# IMMINGHAM EASTERN RO-RO TERMINAL DCO APPLICATION

## PINS REFERENCE TR030007

### SUMMARY OF CASE MADE AT ISH3 BY DFDS

NRA Differences:  
Applicant's NRA and DFDS NRA

Figure 4: Risk Matrix used in the Applicant's NRA

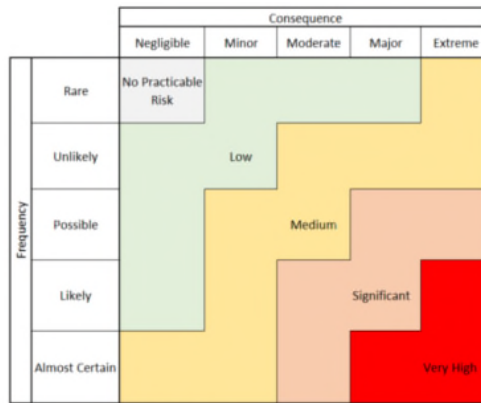
The Applicant's NRA used a risk matrix and risk classifications which did not adopt any scoring mechanism (as shown below). They have instead used basic risk classifications of "Very High", "Significant", "Medium", "Low" and "No Practicable Risk" but these classifications have no relationship to the tolerability on three of the four risk receptors, that is, sometimes significant level hazards are tolerable and sometimes they are not (tolerability differences are discussed in Section 7 below) – making the risk classifications completely irrelevant.

Therefore the definition of the risk classification in the Applicant's NRA has no bearing on whether or not the risk is tolerable and this allows risks to be easily misjudged based on the loose definition of likelihood (using the "word picture") and unclear interpretations of what is deemed tolerable.

Figure 6: Tolerability definition from Applicant's NRA

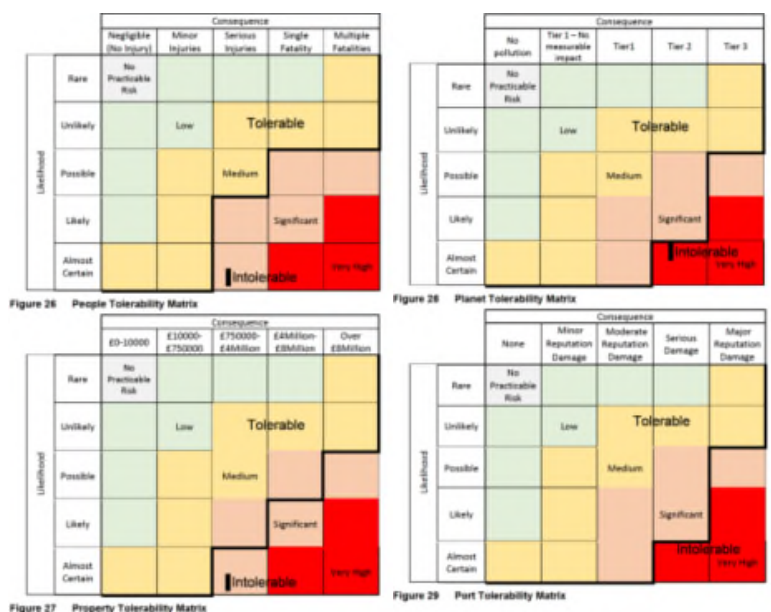
one could be intolerable but the other tolerable – an example is Property damage 4M-8M, when either “likely” or “possible” would be a “significant” risk but one is tolerable and the other intolerable; however as noted above, there is no clear definition of what “likely” or “possible” means. This is entirely illogical and shows that the Applicant’s whole risk assessment process is flawed. Further, this makes it impossible for stakeholders to follow the process and creates significant difficulty in reaching stakeholder understanding, comprehension and ultimately consensus around what the risk is and whether or why it is tolerable.

Additionally, the Applicant’s tolerability does not delineate between the stepped increases to likelihood or consequence, as would be expected in a risk assessment. For example, in the Applicant’s NRA, two hazards with a likelihood of “unlikely”, where one has a consequence to people of “a single fatality” and the other “multiple fatalities”, would score the same (medium risk) and both would be equally tolerable – there is, in effect, no way to differentiate the risk between these hazards using the Applicant’s approach, despite the actual magnitude of the consequences being significantly different.

The methodology used in the DFDS NRA links all parts of the risk assessment through to the tolerability thresholds, which is the whole purpose of a risk assessment. The means of determination of tolerability against each of the four receptor groups of the risk assessment (People, Property, Environment and Port business) can then be determined based on the consequence definitions of those receptor groups which allows the tolerability definition to remain consistent, appropriately structured, and clear to stakeholders. The risk scoring mechanism allows for a structured and objective definition of the distinction between Acceptable, Tolerable if ALARP, and Intolerable risk score ranges used in the risk assessment. This is visually identified in the risk matrix above by colour and facilitates a clear understanding for the stakeholders during the entire risk assessment process.
